PRELIMINARY/FINAL DRAINAGE REPORT

APPALOOSA HWY 24 SUBDIVISION FILING NO. 1A, LOTS 1, 2 & 3

**ADP Project No. 160504
November 9, 2018**

Markup Summary

DETENTION BASIN STAGE-STORAGE TABLE BUILDER

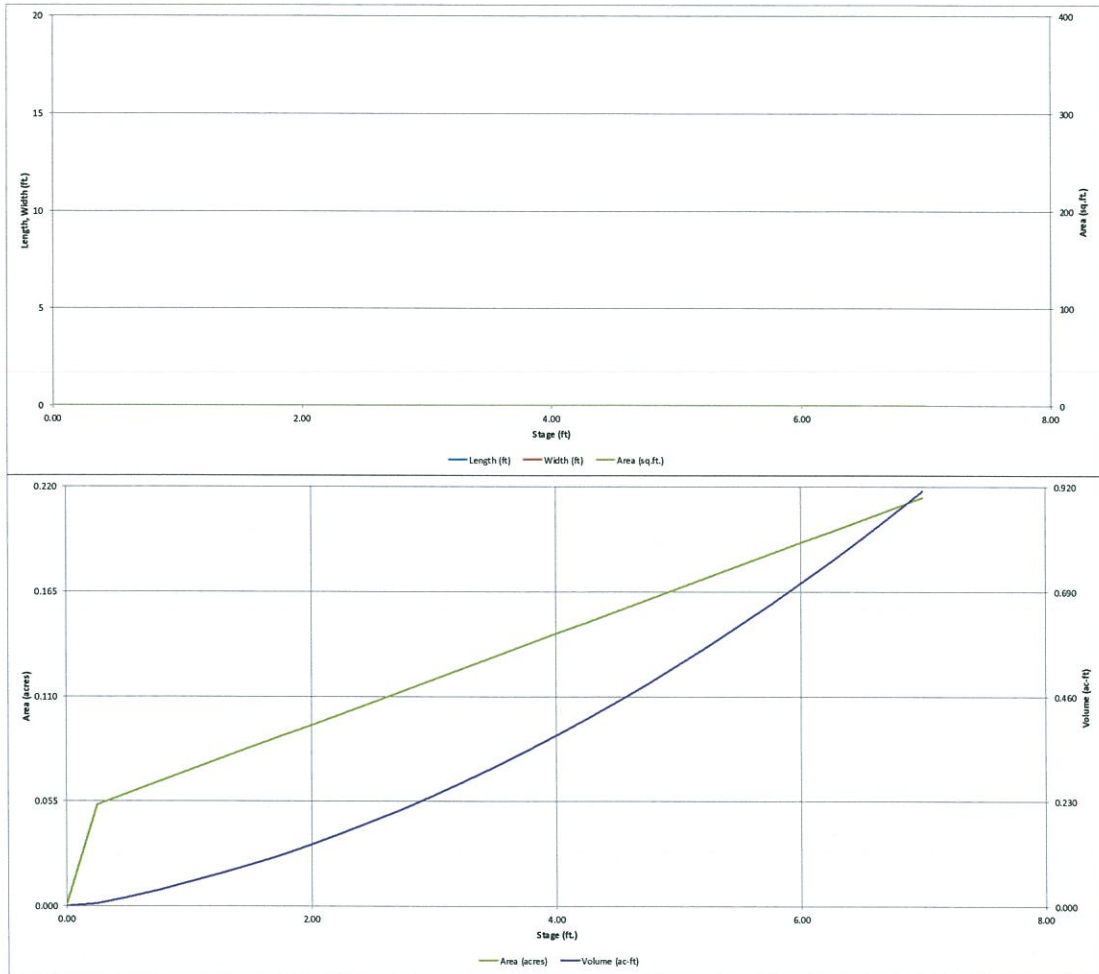
EL @ 6209 on GEC shows an area of 2,888 sf

EL @ 6211 on GEC shows an area of 4,589 sf

These were just spot checks on two elevations showing that the areas in the spreadsheet and on the GEC do not match. Please revise so that the areas in the design spreadsheet and the GEC match.

These volumes do not meet the minimum required for WQCV and EURV.

Detention Basin Outlet Structure Design

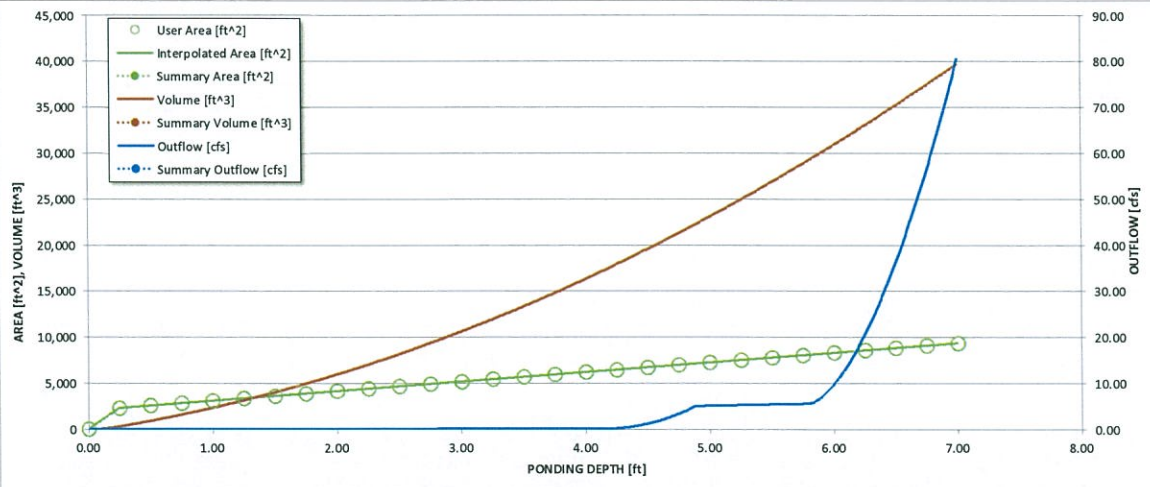
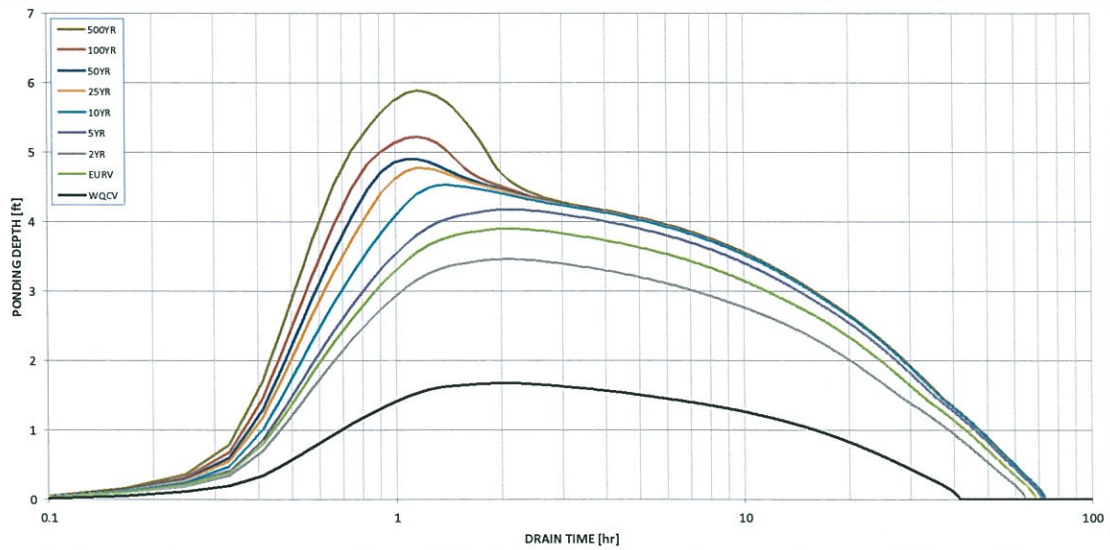
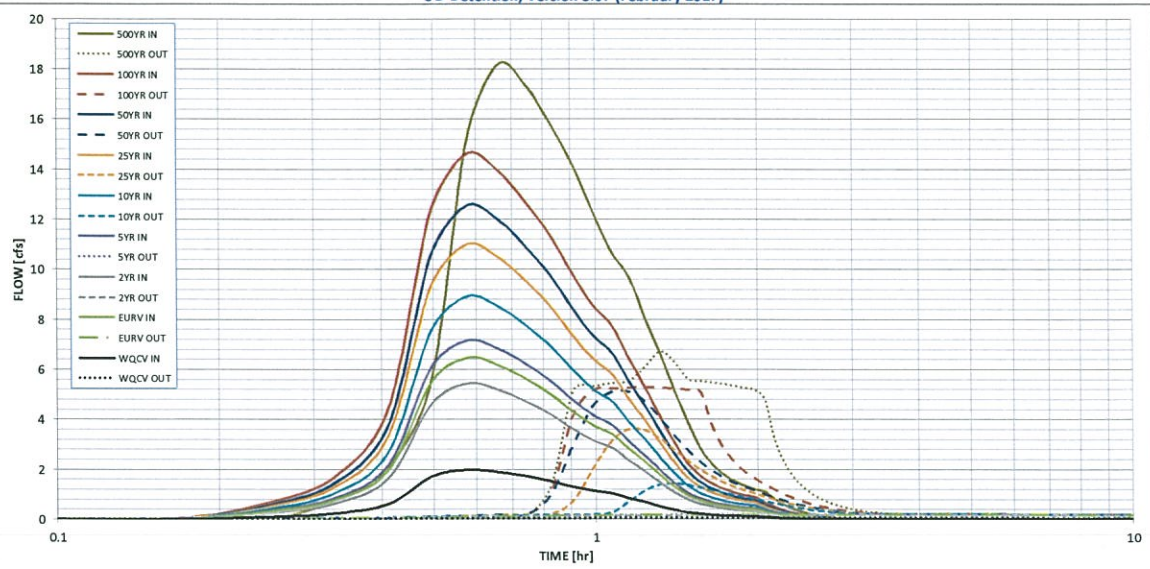
Must release at or below the predeveloped rate. Revise.

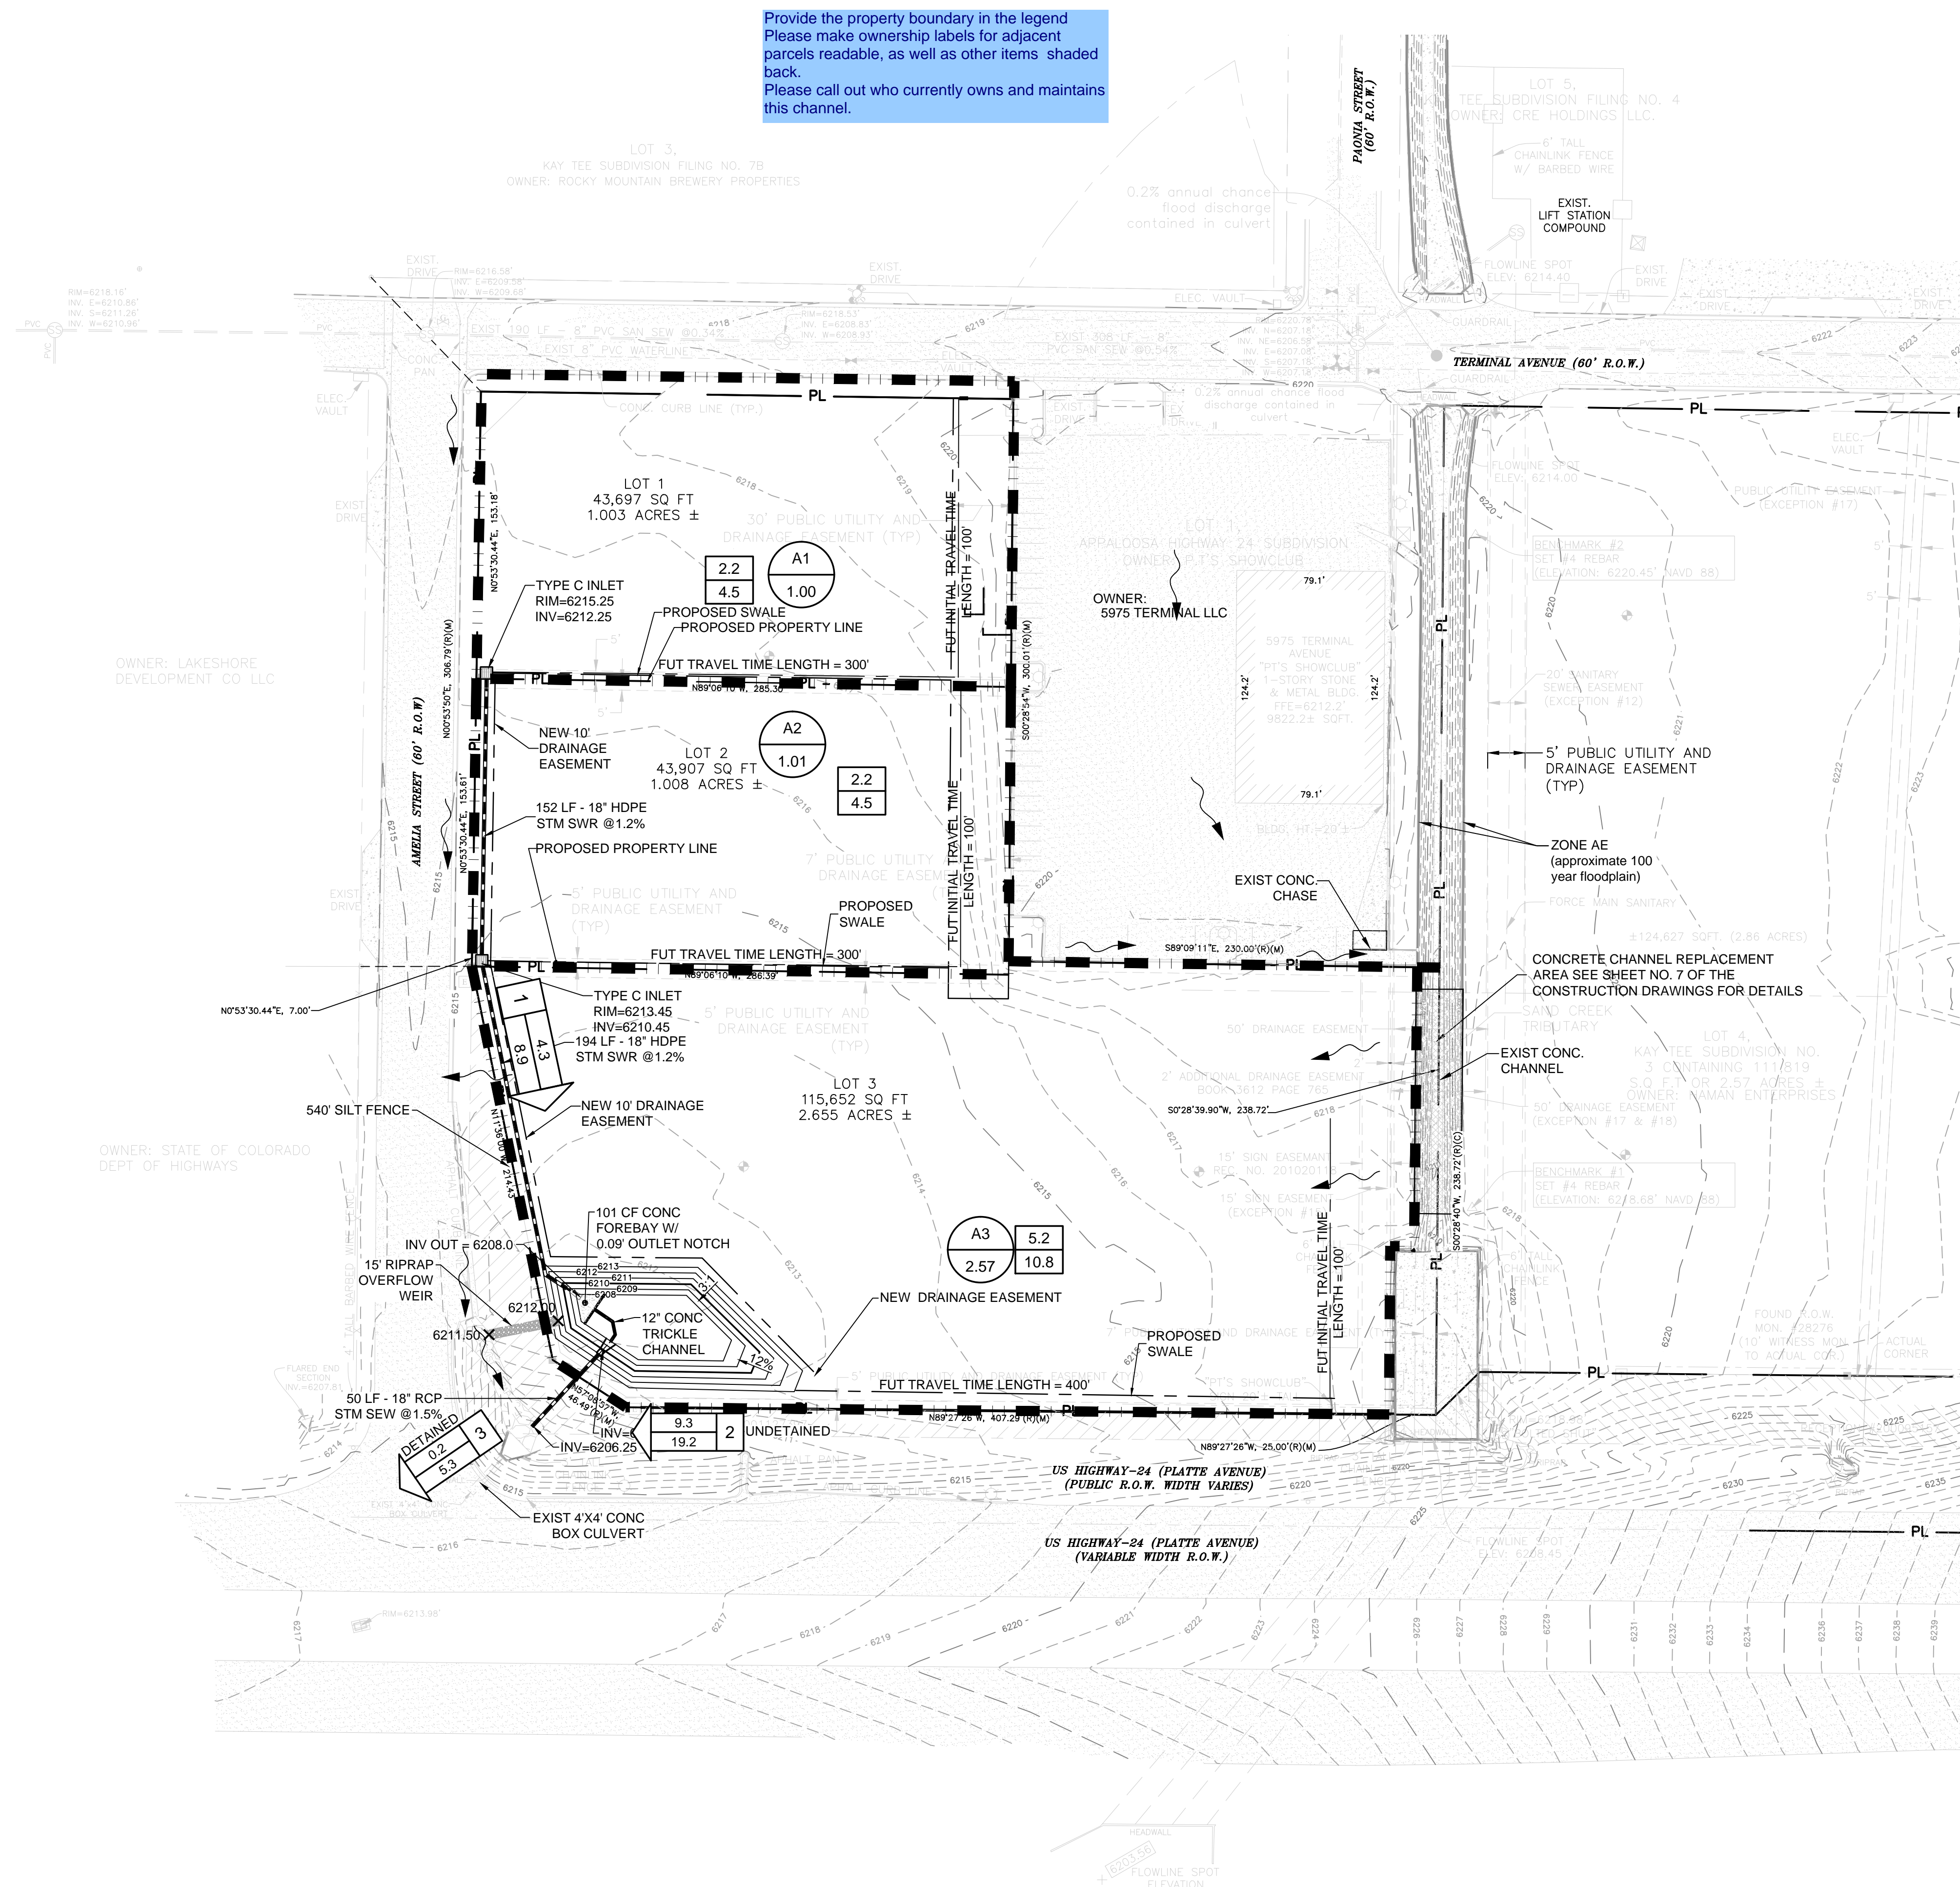
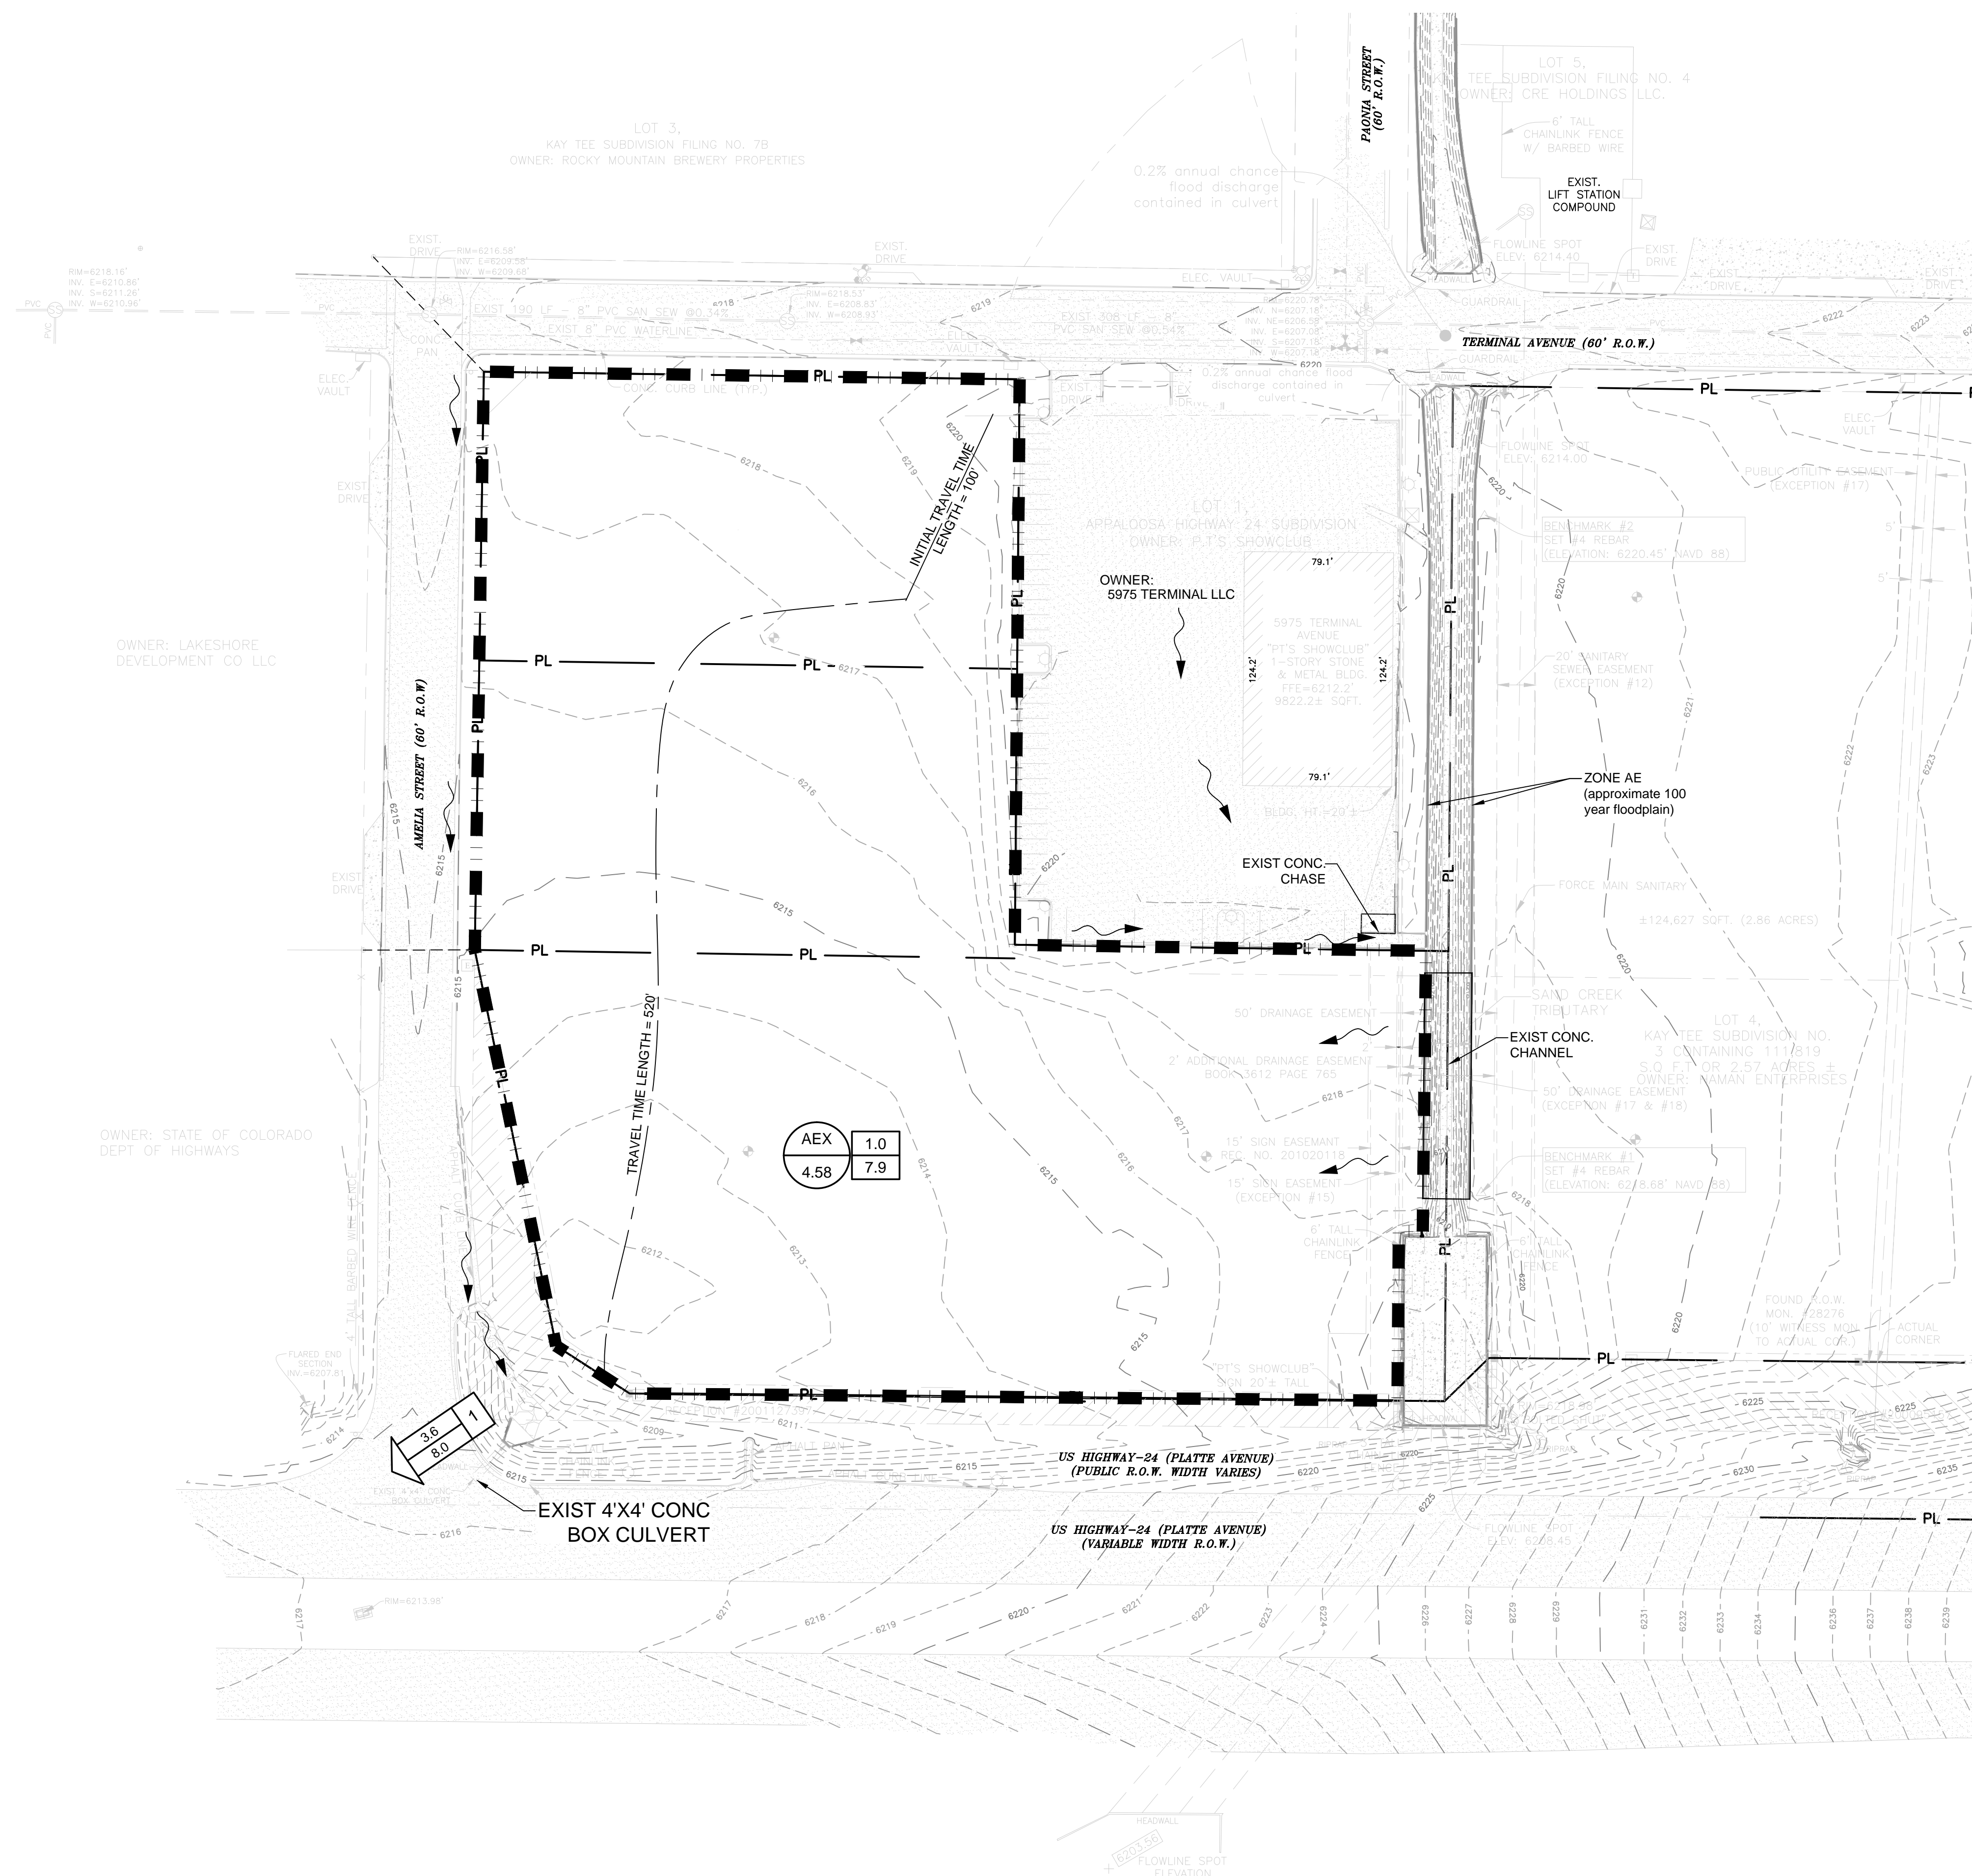
Provide the property boundary in the legend
Please make ownership labels for adjacent parcels readable, as well as other items shaded back.
Please call out who currently owns and maintains this channel.
